STAFF REPORT
COMMUNITY DEVELOPMENT DEPARTMENT

HEARING DATE: 6/28/2022
 TO: Mayor & City Council
 FROM: Joseph Dodson, Associate Planner
 208-884-5533
 SUBJECT: H-2022-0035
 Centrepointe Mixed-Use MDA
 LOCATION: Project is located at 3030 N. Cajun Lane and 3100 N. Centrepoint Way, near the southwest corner of N. Eagle Road and E. Ustick Road, in the NE 1/4 of the NE 1/4 of Section 5, Township 3N, Range 1E.

Request to modify the existing development agreement (Villasport, Inst. # 2019-060877) for the purpose of updating the concept plan and provisions to construct a mixed-use development consisting of commercial space and a multi-family development in lieu of an athletic club/spa and commercial building on 11.17 acres in the C-G zoning district, by Givens Pursley.

CONCEPT SITE PLAN - CENTREPOINT
Eagle & Ustick Meridian, ID

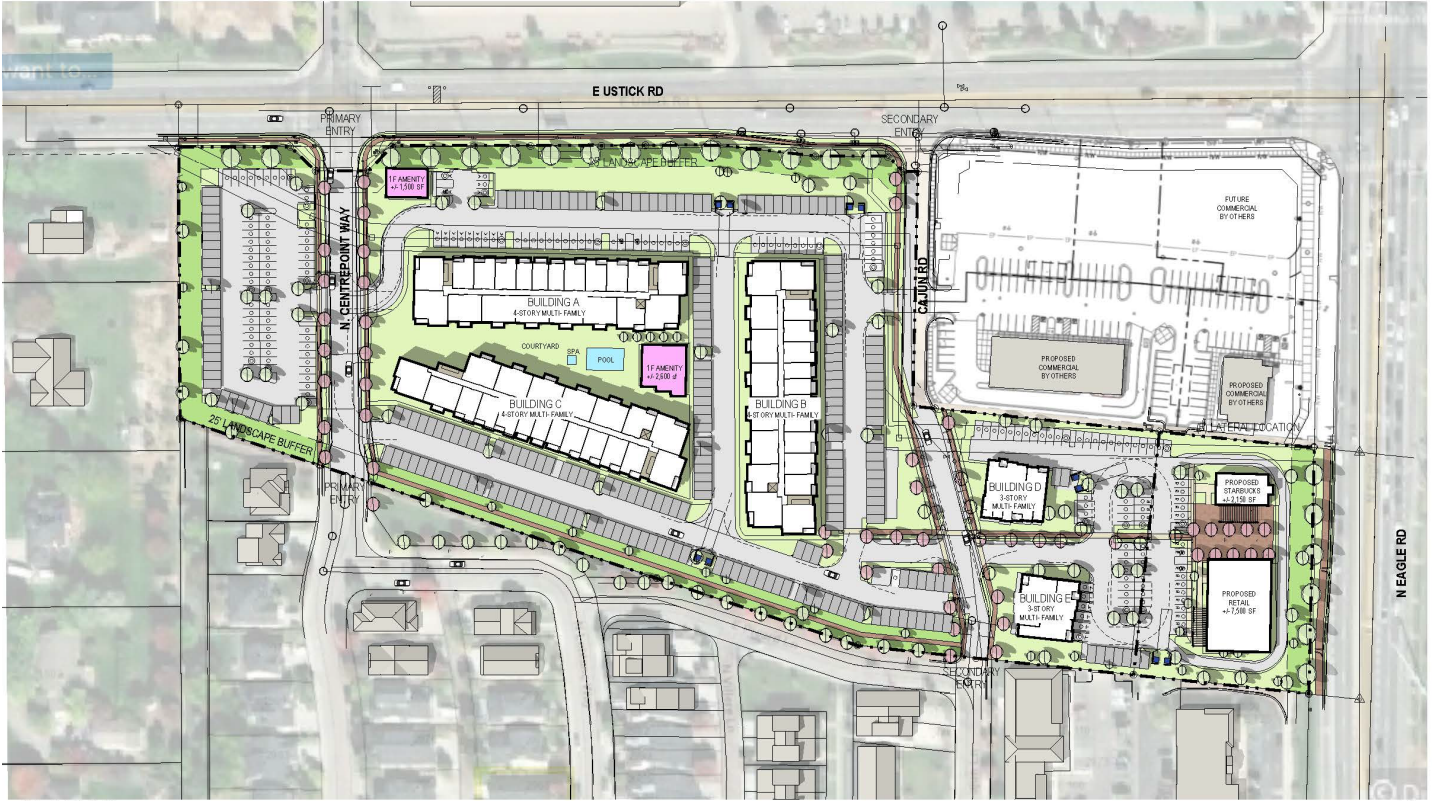
The submitted concept plan (Exhibit VI.B below) depicts five (5) multi-family buildings with internal access (not garden style apartments) and two commercial buildings—the multi-family is split into three (3) 4-story buildings on the larger area of the site west of the Cajun Lane and two (2) 3-story buildings between the two commercial buildings Cajun Lane. The submitted plan depicts at least a 25-foot landscape buffer along the entire perimeter of the site except for the southeast area of the site that abuts commercial uses. Further, it appears no building is proposed within 150 feet of the existing residences to the south of the site and includes the 25-foot buffer, carport parking, a drive aisle, and surface parking between the proposed 4-story apartment buildings and the existing homes. For comparison, Villasport was approved approximately 65 feet from the existing homes. Staff finds this separation should significantly help mitigate any issues with the height disparity of the existing two-story homes to the south and the proposed 4-story buildings. The Applicant has provided a perspective drawing from the intersection of Centrepoint and E. Picard looking northeast to help show the view from the street (see section VI.B).

Overall, Staff finds the proposed layout to be an efficient use of the space for the proposed multi-family use and provides for the safest access available. However, Staff does have concerns with the viability of the proposed open space to meet code requirements and the design of the southeast portion of the site. According to the specific use standards for multi-family development (UDC 11-4-3-27), common open space may not be counted towards the required minimum when it is adjacent to arterials unless approved through the CUP process. Therefore, the proposed open space shown may not all be qualified open space if Planning and Zoning Commission do not approve it in its current location. This is concerning because if the Commission does not approve it, the proposed site plan and open space will not comply with the minimum open space standards and major revisions would likely be needed or a relatively major reduction in units would need to occur to reduce the amount of qualified open space needed.

Staff's other main concern is in regards to the southeast area of the project that depicts two commercial buildings and two multi-family buildings. The required landscape buffer to Eagle Road is 35 feet and the concept plan depicts a 25 foot buffer instead. In addition, the color concept plan depicts the multi-use pathway segment required within this buffer to be completely out of alignment with the two existing segments to the north and south. Because the design for the commercial and drive-through is shown to be directly abutting the 25-foot buffer, the Applicant will need to shift the entire commercial site west at least 10 feet to comply with UDC requirements. Furthermore, the Applicant will need to extend the multi-use pathway from the existing locations on their north and south boundary and place this pathway within the landscape buffer and not within ACHD right-of-way as currently shown.

These required revisions would likely create a need to redesign this area of the project because there will be a reduction in the area available for parking, open space, and circulation. Therefore, to help

mitigate this, and potentially increase the available commercial area, Staff has specific recommendations to City Council to revise the concept plan prior to the Council meeting:

According to the site data table, the multi-family units consist of 41 studios, 108 1-bedroom units, and 110 2-bedroom units to total 259 units. The minimum parking required for the proposed distribution of unit types and clubhouse is 457 stalls with 218 of them covered; the Applicant is proposing 457 stalls with 218 covered and an additional 20 stalls for the commercial to total 477 parking stalls. The commercial drive-through has already received conditional use permit approval but the proposed multi-family residential would require a CUP in front of the Planning and Zoning Commission should Council approve this DA Modification.

However, the site plan contemplates a Starbucks as one of its commercial users which is considered a drive-through restaurant in our code and requires a different commercial parking ratio of 1 space for every 250 square feet. Therefore, the minimum commercial parking required for the proposed commercial area is 24 spaces and the Applicant would need to obtain 4 additional parking spaces in this area of the site based on the elements shown on the submitted plan. It has been Staff’s experience that coffee shops, especially Starbucks, require parking beyond code minimums so the submitted concept plan causes concern for Staff, as discussed above. Further, should additional restaurant uses be proposed, additional parking would be required to meet code or they would not be allowed.

In addition, there are a number of parking spaces proposed west of Centrepoint Way with no other development on this area of the site. In order for future residents to use this parking lot they will need to cross Centrepoint Way which would be anticipated as a busy roadway with the existing residences and the addition of the proposed multi-family. Staff has concerns over the safety of access to this parking lot. Centrepoint Way is public right-of-way so if any crossing is proposed, the Applicant would need to work with ACHD to obtain approval to modify the intersection depicted on the concept plan. **Staff supports the inclusion of bulb-outs and striping at a minimum in order to**

help create safer pedestrian access to and from these areas of the property and the Applicant should work with ACHD.

1. Increase the Eagle Road buffer from 25 feet to 35 feet to comply with the UDC.
2. Continue the multi-use pathway in alignment with the existing locations stubbed to the north and south property lines.

3. Continue the pedestrian network shown along the southern boundary to connect from the west half of the site to the multi-use pathway along Eagle and provide for a connection from the commercial building sidewalks, consistent with code.

4. Remove one or both of two 3-story multi-family buildings or reduce their size to a point that allows more commercial space, more parking, and a plaza that can be more directly shared between the 3-story multi-family buildings and the commercial or the 4-story multi-family and the commercial—there are a number of ways this could be accomplished but Staff is recommending the following:

- a. Remove building D in lieu of a larger shared plaza in its location.
 - b. Reduce or remove the plaza area currently shown as the noise and smell from the Eagle Road traffic largely reduces the appeal of outdoor seating along this corridor.

- c. Increase the size of the retail building for added commercial space.

5. Applicant shall work with ACHD to construct a safe pedestrian crossing from the multi-family site area to the parking lot along the west boundary across N. Centrepoint Way.

6. Prior to the City Council hearing, revise the site plan generally consistent with Staff's recommendations in Section IV.
